UNITED STATES PATENT AND TRADEMARK OFFICE

APPLICATION NO.	FILING DATE	FIRST NAMED INVENTOR	ATTORNEY DOCKET NO.	CONFIRMATION NO.
10/779,674	02/18/2004	Yi-Fang Chou	0941-0918P	8543

Office Action Summary

DETAILED ACTION

FIG. 5a

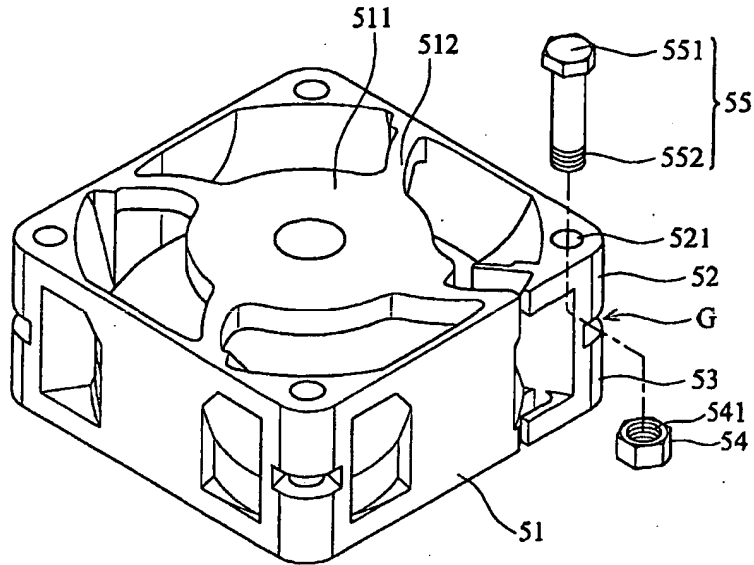
Accepted - Z
